Technical Bulletin

Bulletin No: TCH-008-043

Subject: Recommended Purge Valve Repair Kit

Purge Valve Repair Kit Contents:

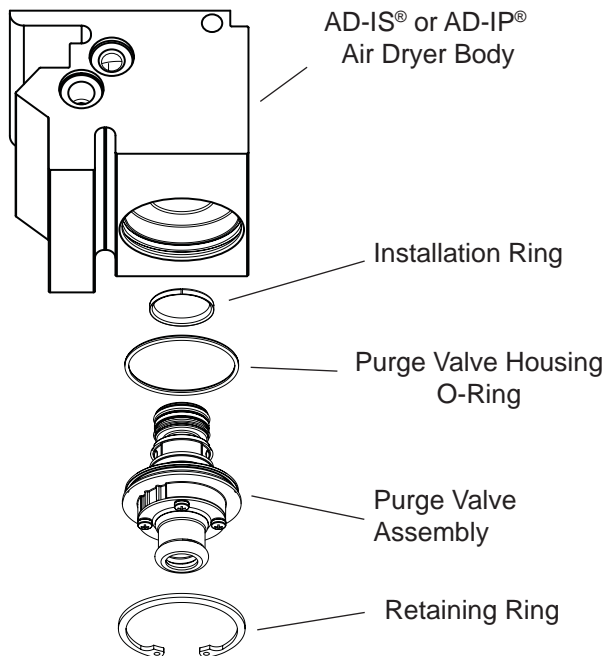
Bendix has developed a Purge Valve Repair Kit, part number K022105, for use on Bendix® AD-IS® and AD-IP® air dryers that experience the valve sticking issue described in Technical Bulletin TCH-008-039. This new repair kit should be used in place of the lubrication maintenance kit, part number 5018313, shown in bulletin TCH-003-039.

The contents of the Purge Valve Repair Kit piece number K022105 are shown here for reference. Installation Instructions are included with each kit to ensure proper servicing.
